MOXY HOTEL CHARLOTTE, NC

CPM Scheduling Consultant: HSE CONTRACTORS INC.

Narrative Report

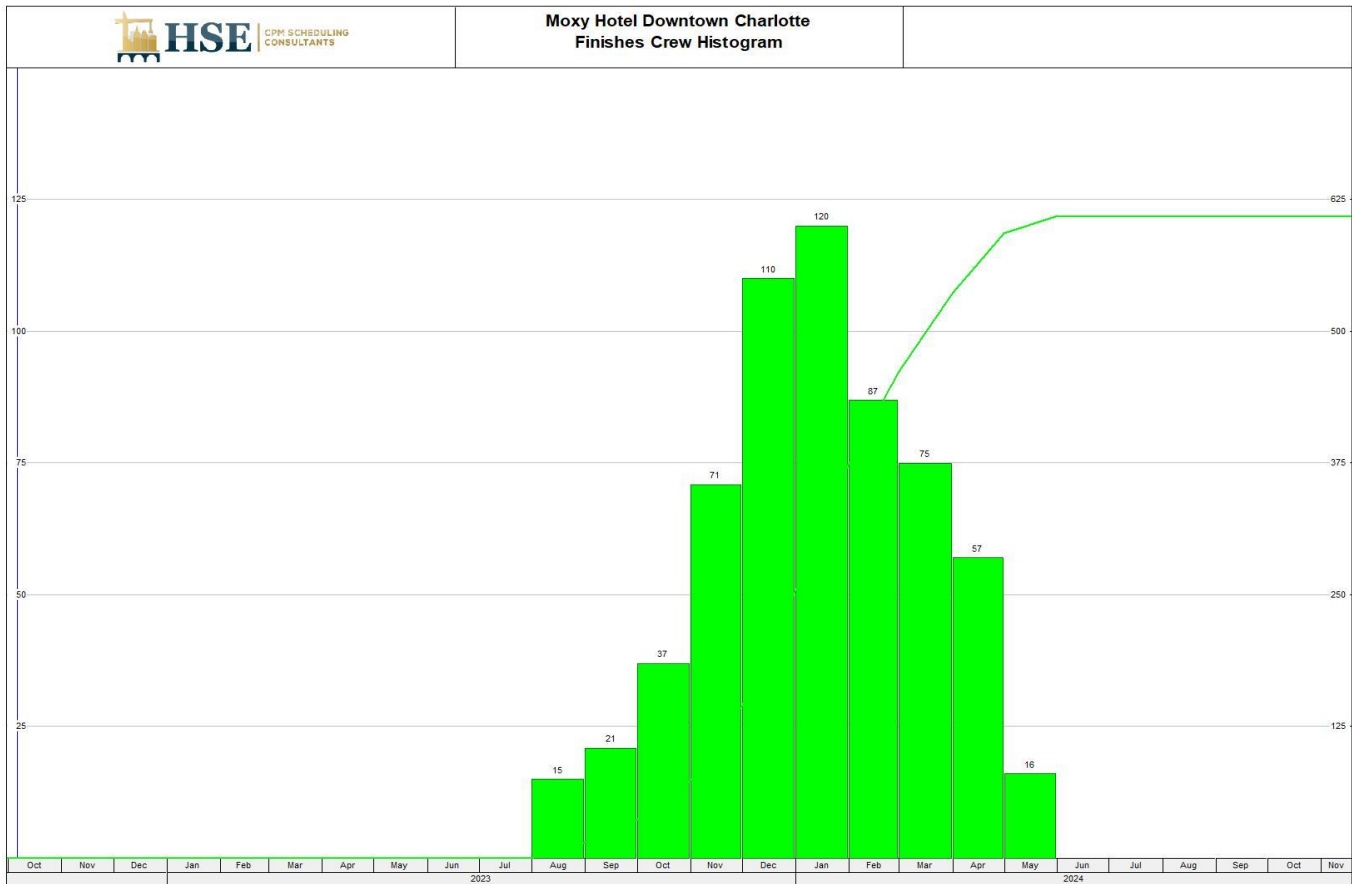
- 1) A3650 Project Final Closeout and Completion
 - 2) A3660 Hotel Opening
 - 3) A3670 Elevator Installation
 - 4) A3900 Structure Topped Out
 - 5) A3910 Temporary Dry In
 - 6) A3920 Building Dry In
 - 7) A3950 BL Harbert Contract Duration
- **Critical Activities:** The baseline contains 77 critical activities out of a total of 238 activities, accounting for 32.5% of the total, which just falls within an acceptable range.
 - **Relationship Issues:** Several relationships between activities include leads and negative lags, which require correction. For example, activity "A1050 Mobilize for Construction" is linked to "A3950 BL Harbert Contract Duration" with a finish-to-finish relationship and a -1day lag, which is not logical.
